**Consolidated Edison Company of New York, Inc.
Former Ossining Works Site, OU-3, Site No. 360172
DNAPL Recovery Well Rehabilitation Work Plan**

Subject: Consolidated Edison Company of New York, Inc.
Former Ossining Works Site, OU-3, Site No. 360172
DNAPL Recovery Well Rehabilitation Work Plan

This letter presents a revised Dense Non-Aqueous Phase Liquid (DNAPL) Recovery Well Rehabilitation Work Plan (Work Plan) for further evaluation and rehabilitation of recovery well RW-D located at Operable Unit No. 3 (OU-3) of the Consolidated Edison Company of New York, Inc. (Con Edison) former Ossining Works site in Ossining, New York (Site No. 360172). The Work Plan has been prepared by Arcadis of New York, Inc. (Arcadis) on behalf of Con Edison. In accordance with the requirements of Section 1.5(b)(1) of the New York State Department of Environmental Conservation (NYSDEC) Division of Environmental Remediation document entitled *Technical Guidance for Site Investigation and Remediation* (DER-10, May 2010), a Certification Statement signed by Arcadis' Engineer of Record for the former Ossining Works site is included as Attachment A. The NYSDEC initially requested the Work Plan in an Octobe

**NAPL RECOVERY WELL
 SPECIFICATIONS**

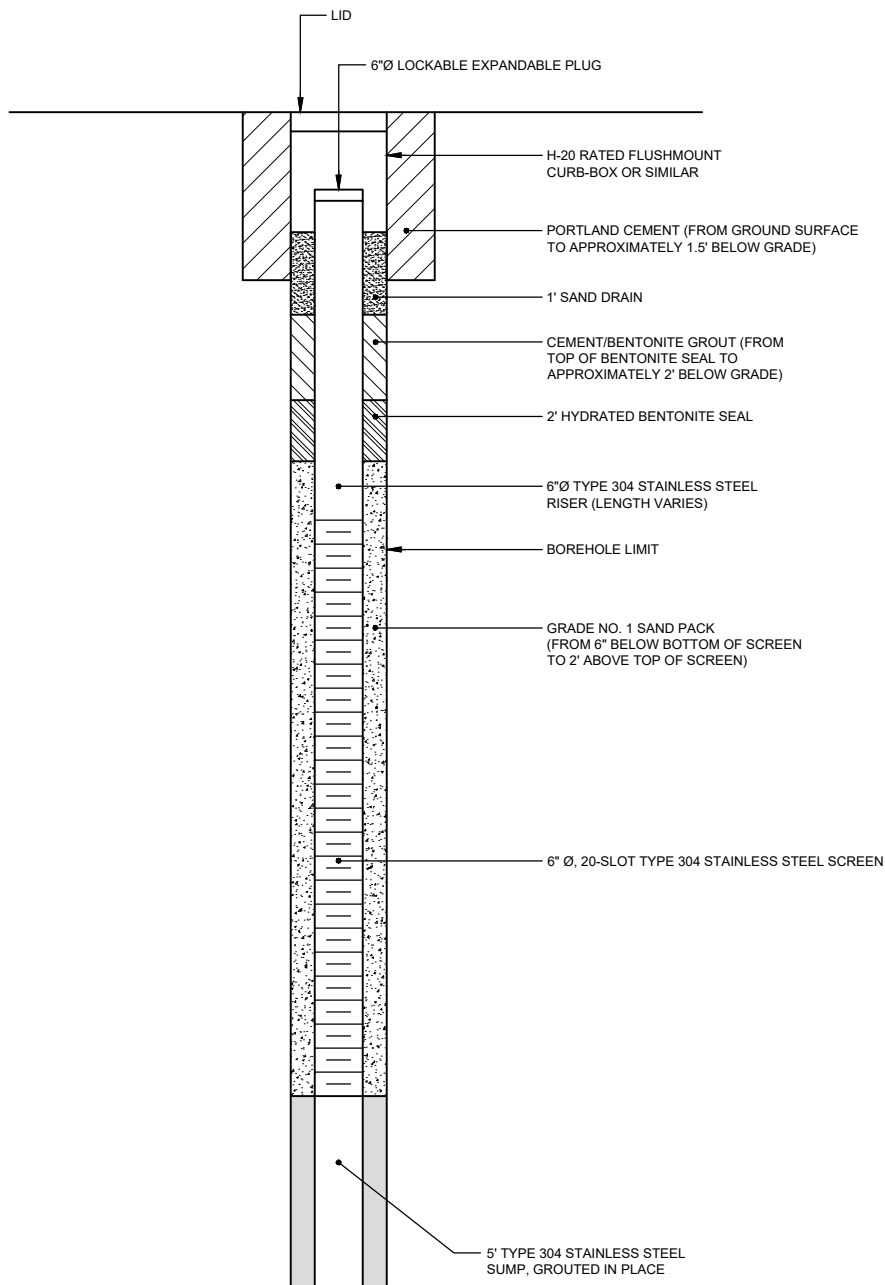
- In accordance with the requirements of Section 1.5(b)(1) of the New York State Department of Environmental Conservation (NYSDEC) Division of Environmental Remediation document entitled *Technical Guidance for Site Investigation and Remediation* (DER-10, May 2010), a Certification Statement signed by Arcadis' Engineer of Record for the former Ossining Works site is included as Attachment A.
- All references to polyvinyl chloride (PVC) well construction materials have been changed to Type 304 Stainless Steel in the Work Plan text and on the Well Construction Diagram presented as Figure 2.

The proposed construction of new recovery well RW-D2 is shown on Figure 2. The new well will be constructed in general accordance with American Society for Testing Materials (ASTM) D5092 - Standard Practice for Design and Installation of Ground Water Monitoring Wells. RW-D2 will be constructed using 6-inch diameter Type 304 stainless steel (stainless steel) well riser with a 10-foot stainless steel screen and 5-foot stainless steel sump. Con Edison anticipates that the screen for the new well will be installed at a depth of approximately 27 to 37 feet bgs (consistent with the existing RW-D). The screened interval will target areas of visual NAPL and elevated PID headspace screening results and may be adjusted based on soil screening from the RW-D2 boring. After installation, the new well will be developed by pumping and surging until the turbidity of water removed from the well is reduced to less than 50 nephelometric turbidity units (NTUs) or a minimum of three well volumes are removed from the well. Following development, the top of casing and ground surface elevation for the new well will be surveyed. The well will be allowed to equilibrate for one week before gauging. If non-aqueous phase liquid (NAPL) is observed, recovery will be performed using a peristaltic pump to pump the NAPL into a drum, consistent with the current monitoring and recovery approach. The NAPL recovery approach will be re-evaluated if appropriate based on the observed NAPL thickness/quantity in the new recovery well.
